REQUEST

Current Zoning: R-22MF (multi-family residential)
Proposed Zoning: NS (neighborhood services)

SUMMARY OF PETITION

The petition proposes to redevelop four existing single family home sites on Reece Road with up to 15 townhome dwelling units and one live work unit at a density of 18.39 units an acre.

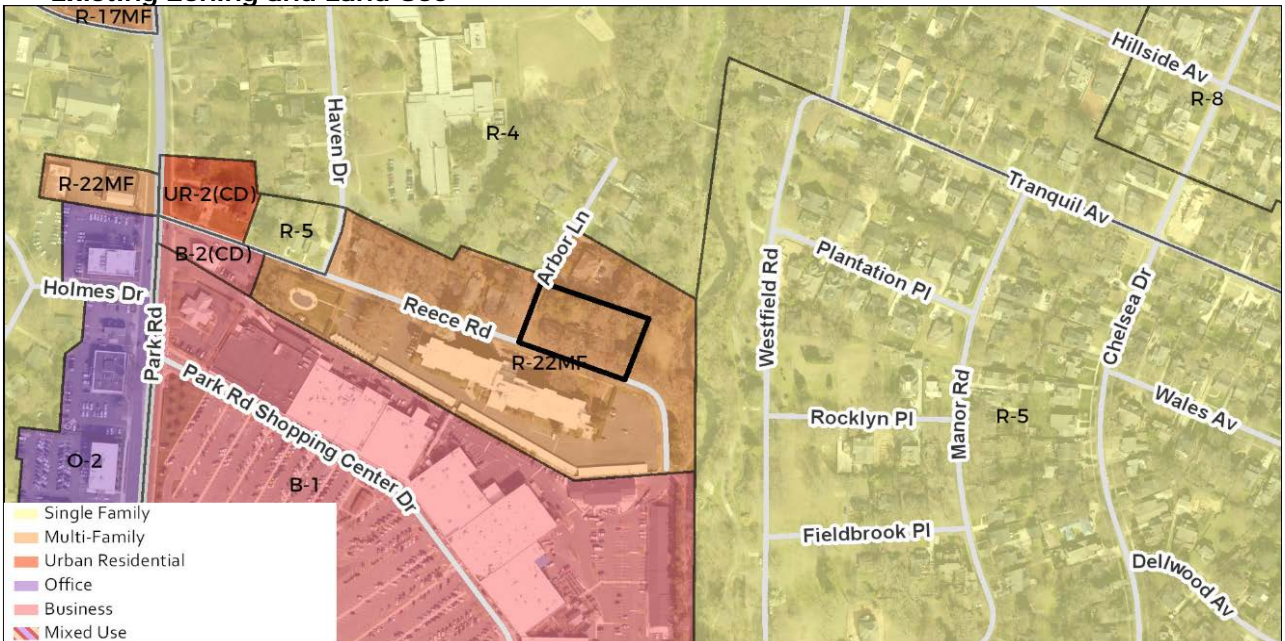
1. Provide a minimum square footage for the proposed tree save area.
2. Eliminate the live work component from the proposed request.
3. Add a note committing to the two four unit buildings along Reece Road.

4. Submit a tree survey for all trees two inches in diameter at breast height (DBH) or larger located in the public right of way. Tree survey may be completed by landscape architect, surveyor, or other land development professional.
-
